95% FIRST SERVICE WATER & SEWER DIOMEDE, ALASKA REV1

Enhanced Preliminary Engineering Report

ANTHC DO 23-D-200815/DOWL PO 50290.01

APPENDIX 15: RESPONSE TO COMMENTS

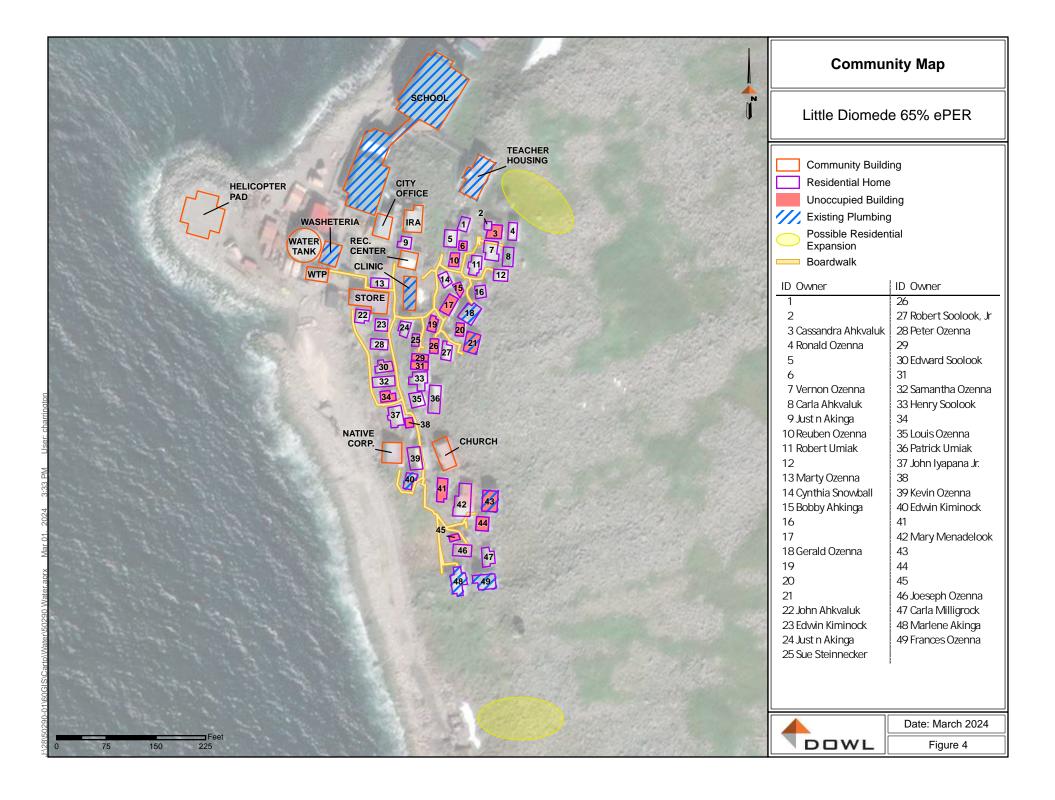
5	MM	MW		4			Figure 4: There are 49 numbered buildings. If we assume these are all residences, and remove the unoccupied residences (about $1/3$), then 49 - $17 = 32$ potential residences we might be able to provide with water and sewer services. It is confusing that the system proposed is said to serve 33 homes. Where does the extra home come from?	33 services includes an additional home to account for population growth. The expected services will be changed to 32 homes, as that is the number of homes currently occupied. User costs have been calculated assuming 32 residential services.	
6	MM	MW		4 and 21			Figure 4 versus Figure 13: When the figures are compared we see that of the 32 homes that are identified as occupied, 12 are not "Structurally stable". This adds further confusion to why we are proposing to serve 33 homes since 32 - 12 = 20. These two graphics and the data contained within them should be summarized in a single graphic or table to inform the reader how many homes can be connected to the proposed system. This is of critical importance in this, or any, PER.	The expectation is that the 12 homes, which are suspected to have structural instability, will undergo further assessment and could need rehabilitation before the construction begins. These homes are anticipated to become rate-paying customers. Please refer to the response provided in comment 9 for more details.

96	LBC	MW	page 7 of 626 - Introduc tion and page 32 of 626 - 2.2 History	the WTP construction is now in progress	Noted.	
97	LBC	MW	page 12 of 626 - Figure 4	Is there a reason not to mark the school, washeteria and clinic as plumbed? I believe all three buildings have at least seasonal housing	This is correct and will be updated.	
98	LBC	MW	page 31 of 626 - Figure 14	The raw water system was cut and capped during the new water plant construction and doesn't connect to the WTP anymore. The routing of the service lines is a bit off in this figure see the snip below where bright green means delete and light blue means add	Noted. Snip has not been included in our comment documents.	
99	LBC	MW	page 34 of 626 - 2.3.2	Construction completion of the WTP is planned for 2024	Updated in report.	
100	LBC	MW	page 35 of 626 Distribu tion System	Can you explain the use of bypass here? Are foks bypassing the treatment?	Residents are bypassing the watering point by going into the WTP to collect their water. The hose being used delivers treated water.

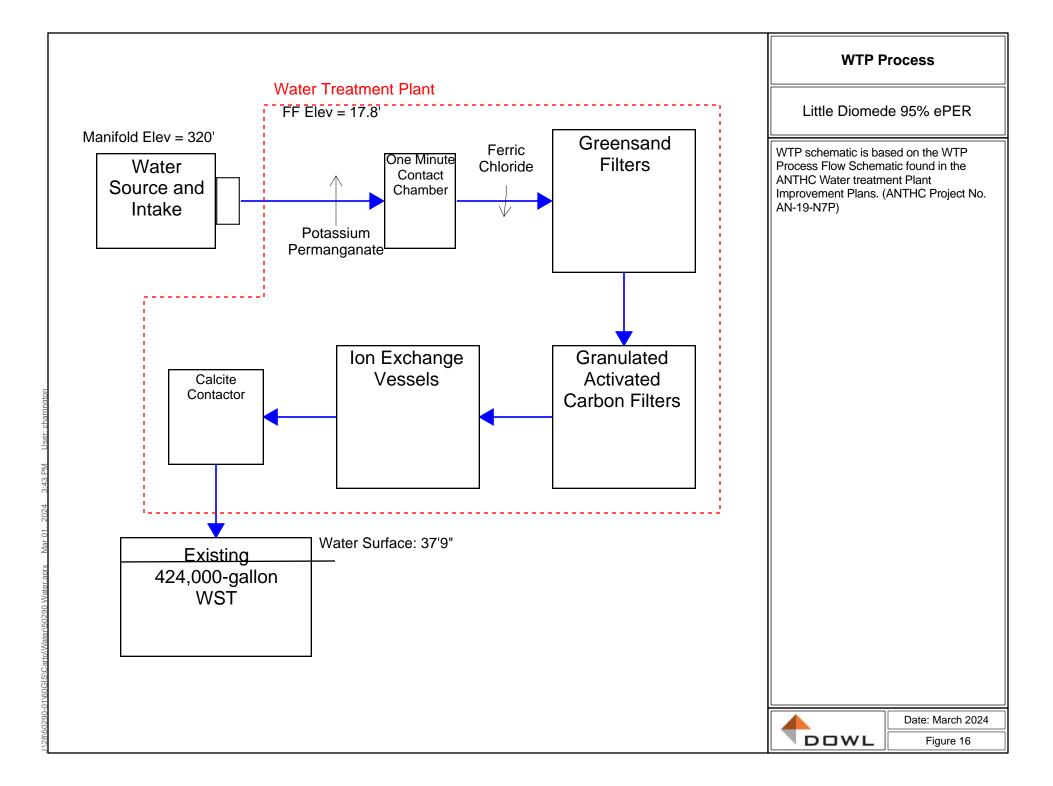
10	MM	MW		23			Figure 14: Is the "Old Summer Raw Water Pipe" the same as the what is described on page 22 under the second bullet?	Yes.	
11	MM	CS		28			Figure 16: Wouldn't it be easier to just show the P&ID for the referenced project? Also, if we are going to refer to an ANTHC project, we should reference the ANTHC project number.	The ANTHC project number will be added. The simplified schematic is intended for any readers unfamiliar with a P&ID.	
12	MM	MW		31			Last sentence: This is non-technical, unprofessional wording. We don't talk about what "ails the system". We might discuss "inoperability" or "deficiencies".	Language has been changed in the document.	
13	MM	MW		35			3.3: We state here that the population of is "estimated to grow" to 93 residents. That estimation exists only in this report for purposes of planning. We should be clear where this comes from and refer the reader to the page where that is was established.	Section 1.3 has been referenced in this section.

sufficient for secondary treatment.
124	NSHC	MW		31	Figure 14 typo on "Approximate Wastewater Outfall Location" callout	Fixed.
125	NSHC	MW		39	End of third paragraph. Typo "Coast" instead of "Cost"	Noted.
126	NSHC	MW		42	Table 5. Is labor for the WST really only \$2 annually? Labor for tank	This is a mistake and has been fixed.
					cleaning should make this higher. Sec 4.3.1. The septage vault is referred to as a lagoon in one bullet and	
127	NSHC	MW		58	a vault in another. I think it's supposed to be vault - language needs to	Noted. Updated throughout the report.
					be consistent. Table 22 doesn't show any numerical scoring but the last paragraph on	
128	NSHC	CN		85	the previous page makes reference to numerical scoring	See response to comment 77.
129	NSHC	MW	G	eneral	With this PER recommending R/O, will the ANTHC project to install ion exchange in the WTP still go forward?	Yes. The ANTHC WTP upgrade is separate from this first service project.

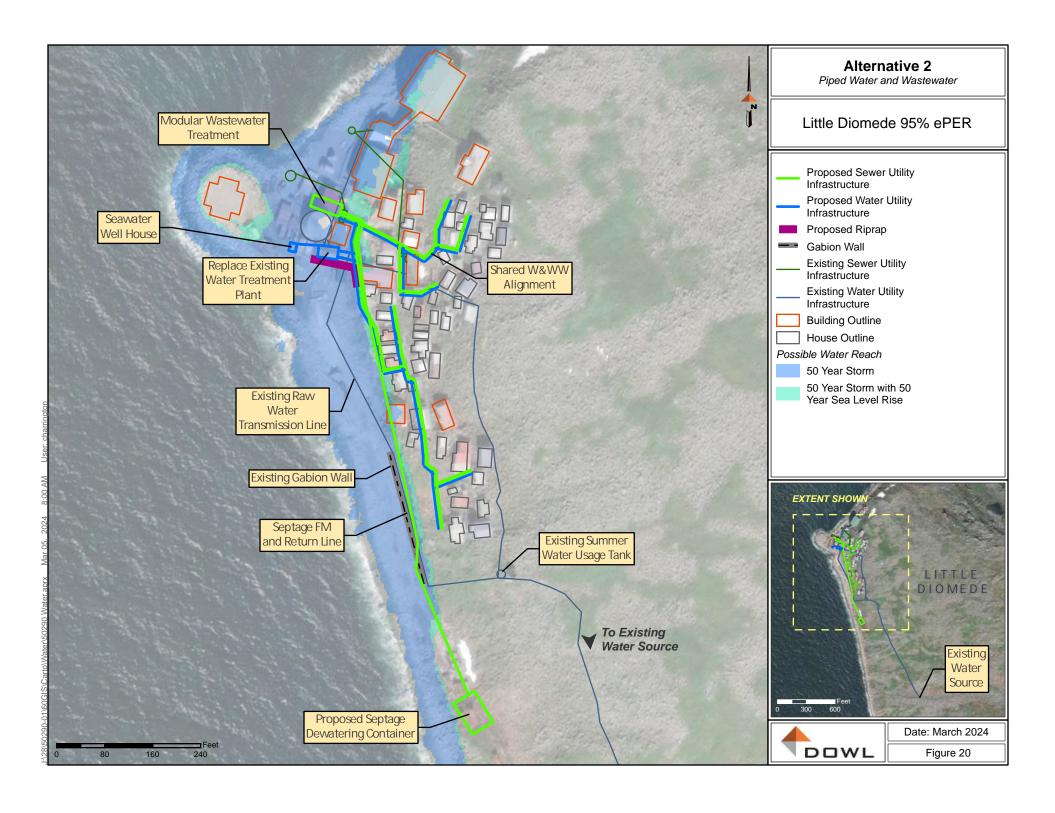
RH MW 78-82, Fig. 20 95% ePER September 165 Pig. 20 95% ePER RH MW 78-82, Fig. 20 95% ePER September 2012 Pig. 20 Pig.	164	DH	CN	Capital		percentages listed based off of as they do not seem to be based off of the Construction cost of \$16,060,000? Ie. Design (10%) would only be \$1.6M if taken as a percentage of construction, but instead \$3.8M is		
END OF COMMENTS	165	RH	MW		95% ePER	concurrences for the proposed work on the water treatment plant and water storage tank under projects AN 19-N7P and AN 19-T84 (respectively, SHPO Files 3130-1R ANTHC 2022-01313, and 3130-1R ANTHC/2020-00600). SHPO consultation has not been done for the water distribution and sewage collection systems proposed as selected Alternative 2. Due to the significant number of cultural resources present in the project APE, a SHPO consultation is required. Construction monitoring for the water distribution and sewage	Noted.
